Docket Number:	24-OPT-05
Project Title:	Corby Battery Energy Storage System Project
TN #:	269192
Document Title:	Data Response Set #5
Description:	Response to Project Description Update #2 Supplemental Data Requests
Filer:	Doug Urry
Organization:	Tetra Tech
Submitter Role:	Applicant Consultant
Submission Date:	3/13/2026 3:53:13 PM
Docketed Date:	3/13/2026

Data Request Response #5

Corby Battery Energy Storage System Project (24-OPT-05)

Figure 4-1. Corby BESS Acute HI > 1.0³

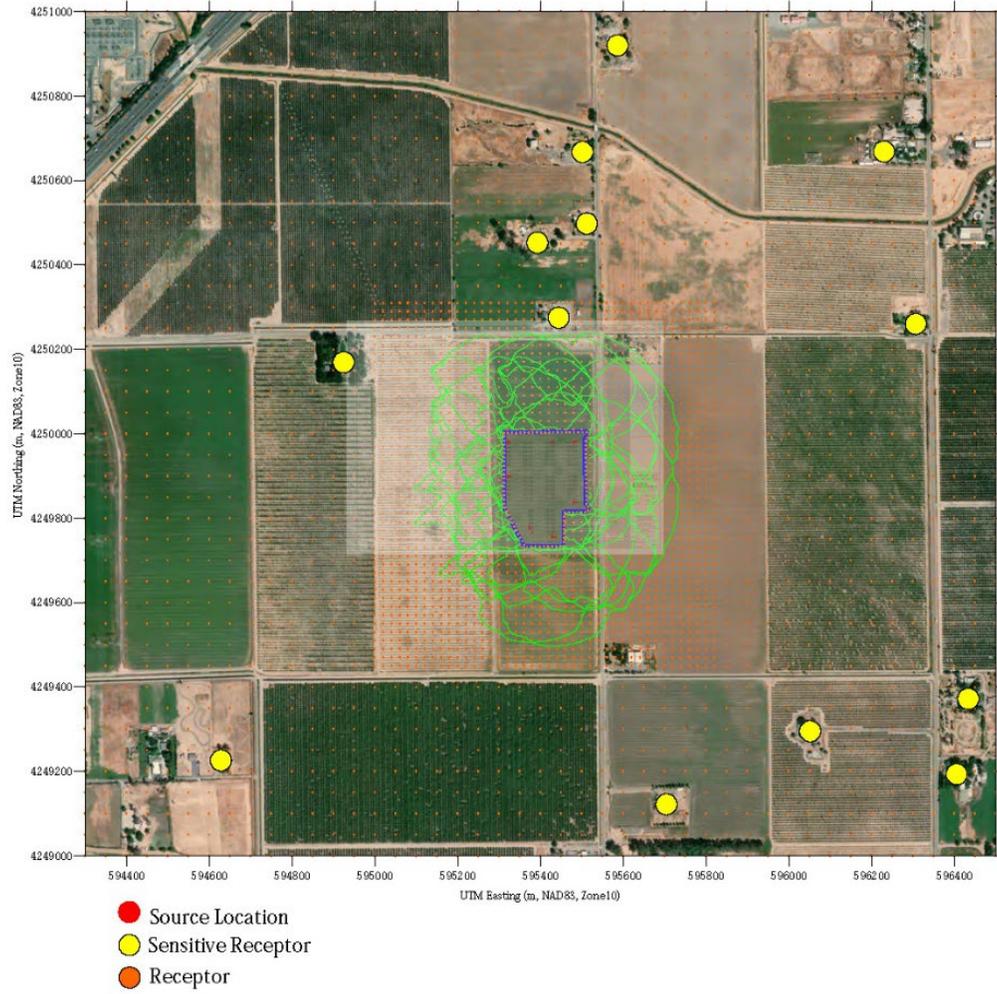
SDR TR-1. Please provide the impacts calculation spreadsheet including the modeled worst-case 1-hour concentrations used for each pollutant at the maximally exposed individual receptor, along with identification of corresponding modeling scenarios from which concentration value was selected.

Response: No separate emission/concentration spreadsheets were created outside of the Hot Spots Analysis and Reporting Program (HARP) risk model. AERMOD output files, in .PLT format, were input into the HARP2 Risk Assessment model (Version 22118) from which the acute impacts were calculated. These files were supplied to the CEC. In particular, HARP generated the file "Corby11NCAcuteRiskSumByRec.csv." which displays that receptor 986 has a calculated HI of 0.260. The HARP generated file "Corby11NCAcuteRisk.csv" provides the individual concentrations by pollutant at each receptor. The modeled impacts of nitrogen oxides (NO_x), sulfur oxides (SO_x), and carbon monoxide (CO) were taken directly from the AERMOD output file, which is based on a one (1) gram/second emission rate, and the results were prorated to reflect the actual emissions of those pollutants. As noted in response SDR TR-5, particulate matter was also included as a modeled pollutant.

Based on discussions with CEC staff, the acute modeling analyses were revised to reflect the use of the 95% upper confidence limit of the arithmetic mean (95% UCL) across all of the test data in the Ramboll Offsite Consequence Analysis (OCA) report (Ramboll 2024). This data set was also supplemented with additional data from INERIS (2022), Willstrand et al. (2020), Hynynen (2022), and Truchot et al. (2025). The 95% UCL replaces the use of the arithmetic mean. The U.S. Environmental Protection Agency (EPA) ProUCL (Version 5.2) program was used with the emissions data to calculate the 95% UCL for hydrogen fluoride as the sample size exceeded 10 observations. For hydrogen chloride, hydrogen cyanide ammonia, formaldehyde, fine particulate matter, and sulfur dioxide, where the sample sizes were not sufficient to quantify the 95% UCL, typically with less than 10 data points, the maximum values across all of the test data were used.

The acute modeling assessments were also updated to reflect the addition of formaldehyde and ammonia and fine particulate matter (PM_{2.5}) to the emissions inventory, as also noted in response to SDR TR-5. The revised HI modeling results are provided in Table 4-1. Figure 4-1² represents the maximum distance of the HI equaling or exceeding 1.0 from any of the 14 hypothetical locations of unexpected thermal runaways at the BESS under meteorological conditions that can produce the highest ground level concentrations at a sensitive receptor.

Figure 3.1-14

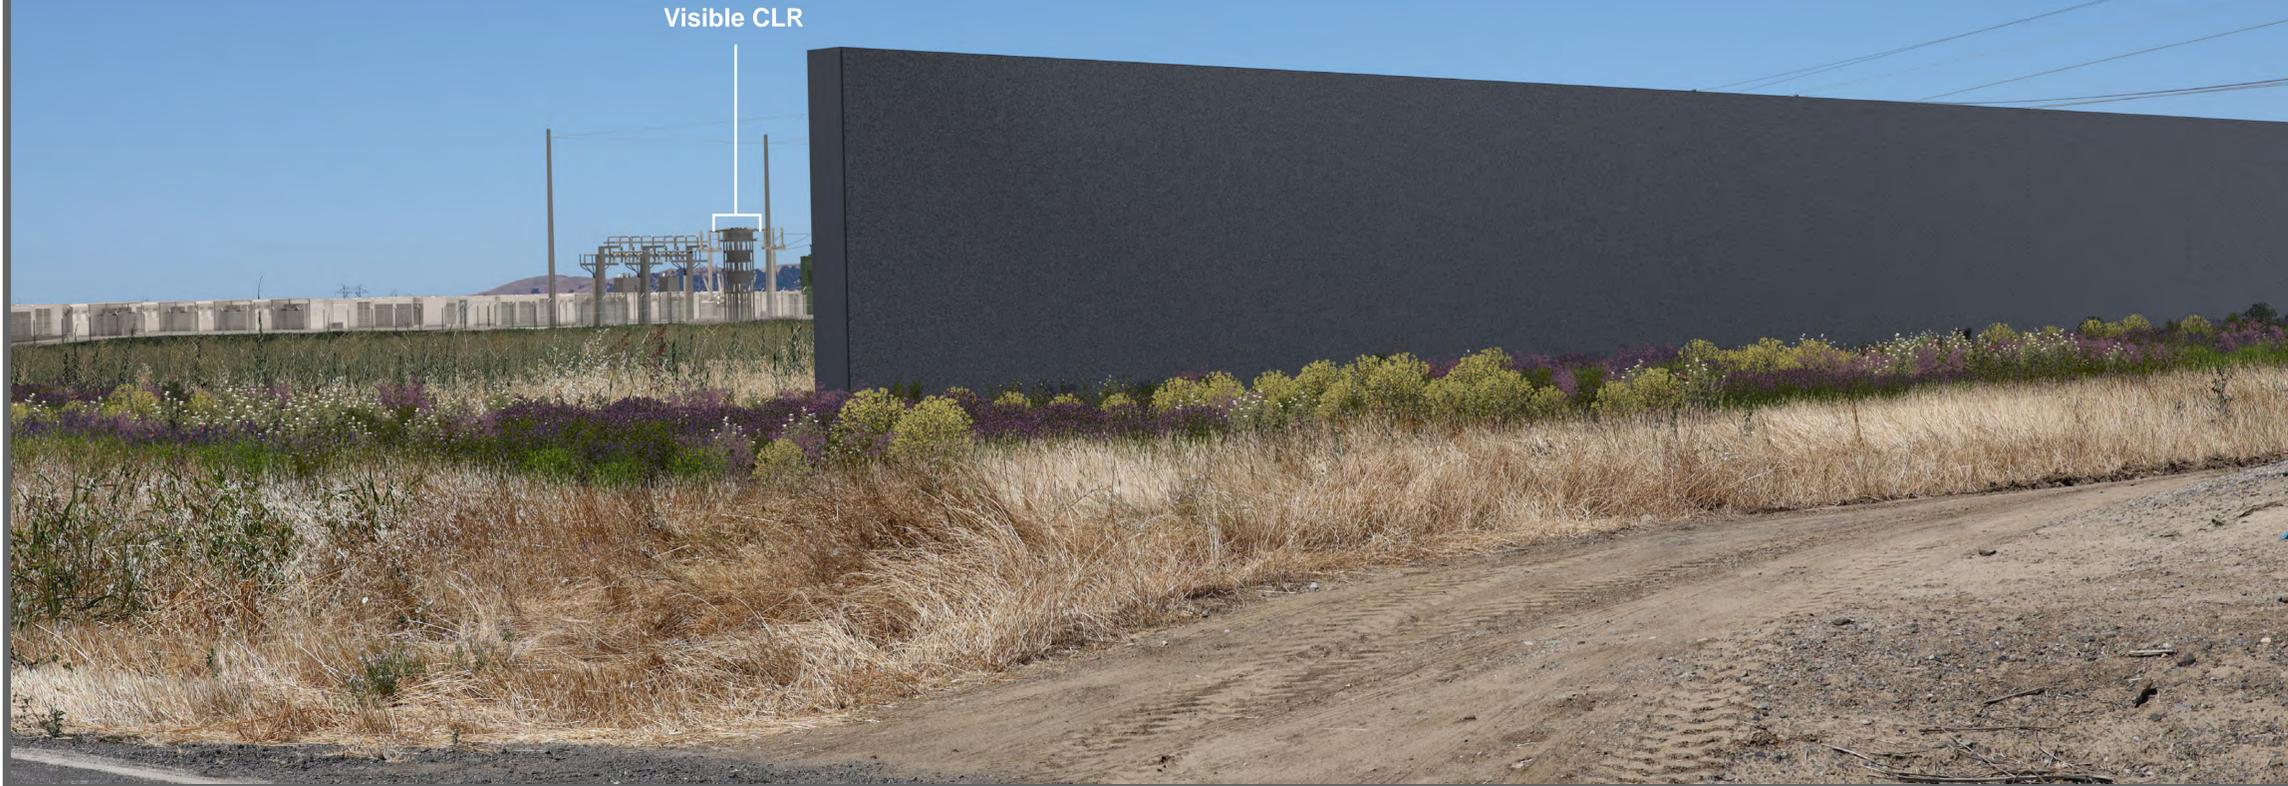
SDR VIS-1. Please provide additional information/guidance as to where, precisely, the CLRs are located in simulations 2a, 3, 7a, and 7b.

Response: The text within Project Description Update #2 incorrectly stated the two CLRs would be visible from key observation points (KOPs) 2a, 3, 7a, and 7b. The CLRs are visible only in KOPs 2b, 3, and 7b. The CLRs are located outside of both KOP 2a and KOP 7a.

While evaluating the simulations provided under Project Description Update #2, it was noted that there was a minor discrepancy in the height of the CLRs. As a result, Figures 3.1-3, 3.1-4, 3.1-8, 3.1-11, and 3.1-12 have been updated to reflect the correct height of the CLRs. As shown in the updated figures, the CLRs continue to blend in with the substation equipment. At KOP 2b, the CLR is more visible than from the other KOPs as it is in the forefront of the substation equipment; however, when looking at the substation collectively, the CLR is of equivalent height and color as the surrounding equipment and the unit blends into the view. Further, although the CLR in KOP 2b is noticeable at the 1-year landscaping milestone (Figures 3.1-3 and 3.1-14), at 5 years (Figures 3.1-8 and 3.1-14) the landscaping effectively obscures most equipment including the CLRs, reducing visual impacts.
